STAFF RECOMMENDATION

CASE FILE NO.: Z0492-19-D

PROPOSAL: Construction of three new self-storage buildings totaling approximately 135,000 square feet, along with a leasing center and caretakers residences. Proposed project also includes revisions to site access, circulation, parking, landscaping, and other redevelopment as required by the Clackamas County Zoning and Development Ordinance.

Landscape Plan

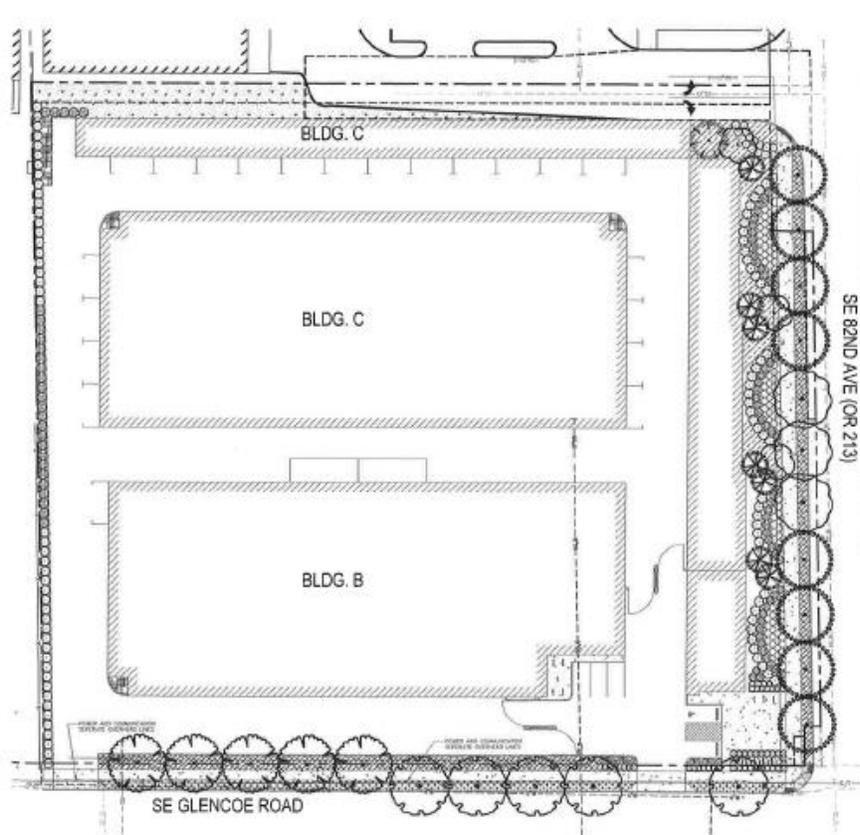
Finding: The proposed development is within the Portland Urban Growth Boundary. Street trees are provided in the landscape plan around the perimeter of the site. These standards are met.

Finding: The proposed site design is 10.7% landscaped area, and will exceed the 10% requirement of the design standard in the CC zone. A variety of plants of various sizes, textures, and seasonal interest are indicated, none of which are invasive or noxious species. These species are predominantly native and/or drought tolerant plants, appropriate to a commercial context and the local habitat/conditions. Conditions of approval will ensure compliance with the required landscaping in terms of composition of materials, installation and maintenance of landscape, and irrigation as well as buffering between the commercial use and adjacent residential uses. **With the conditions of approval in Section 2, the above findings and the applicant’s submitted drawings, the proposed development meets the standards. As conditioned, these standards are met.**

1. Prior to issuance of certificate of occupancy, applicant shall submit a signed maintenance contract guaranteeing the landscape materials for one year from the date of installations or provide a performance surety pursuant to Section 1311, Completion of Improvements, Sureties, and Maintenance, covering the landscape maintenance costs for the one-year period, per ZDO 1009.10(F).
2. Prior to issuance of certificate of occupancy the landscaping installation, lighting, and irrigation system shall be inspected to ensure compliance with submitted drawings and the standards of ZDO 1009.
3. Prior to the issuance of building permits, the applicant shall submit a final proposed signage plan demonstrating compliance with the dimensional standards of ZDO 1010.
